APPLICATION FOR PERMIT TO DRILL, RE-ENTER, DEEPEN, PLUGBACK, OR ADD A ZONE

#### **Tory 3 Fed #1 Recompletion**

#### **Notice of Intent**

> Tory 3 Federal #001 1980' FNL & 1525' FWL Sec 3 - 21S - 32E Lea County, NM API: 30-025-36336 WELLBORE SCHEMATIC

Tory 3 Federal #001
1980' FNL & 1525' FWL Sec 3 - 21S - 32E
Lea County, NM
API: 30-025-36336
WELLBORE SCHEMATIC
Spudded: 7/23/2003

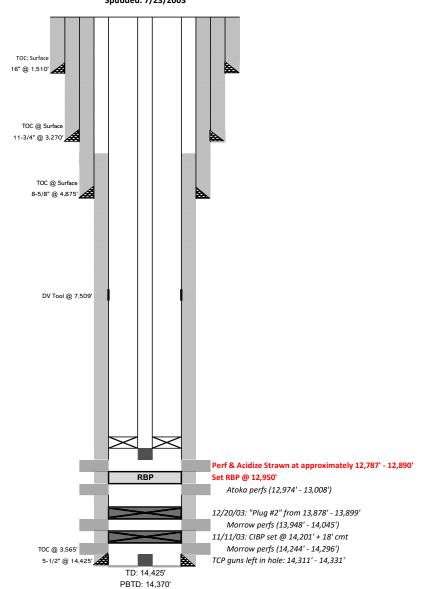
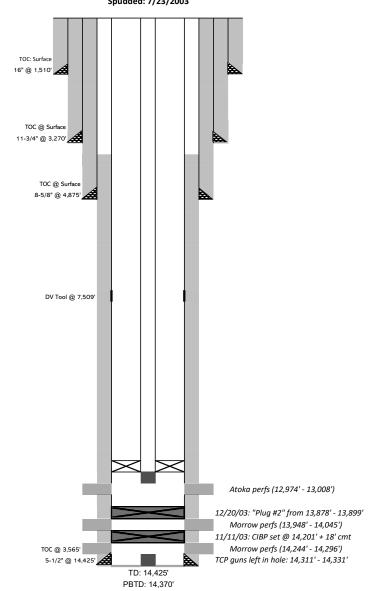
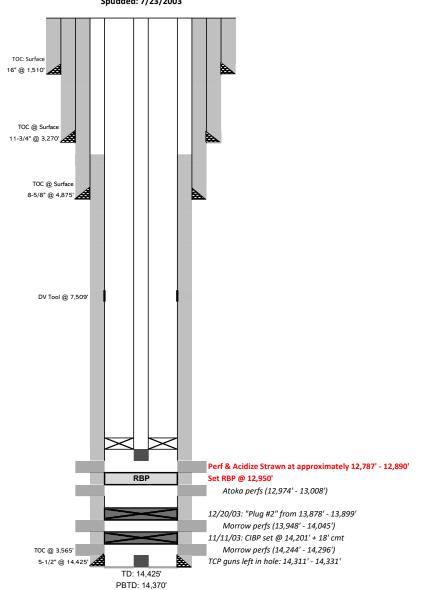
Matador is requesting to plug back the Atoka & recomplete in the Strawn at the Tory 3 Federal #001; per the required COA, following the procedure below:

- Notify BLM 24 hrs before MIRU.
- Safety mtg, MIRU, check pressures, ND wellhead, NU & test BOPs, POOH w/ tbg.
- RIH & set RBP at 12,950'; Pressure test casing.
- RIH & Perforate the Strawn from approximately 12,787' to 12,890'.
- Run tubing & acidize perforations prior to swabbing & returning to production.

BLM Note: Procedure OK as proposed. Pressure test to 500psi, 30mins. Please review COA below. After operations are completed, please submit Recompletion Sundry to update Completion Report and a Subsequent Report to update Well Status
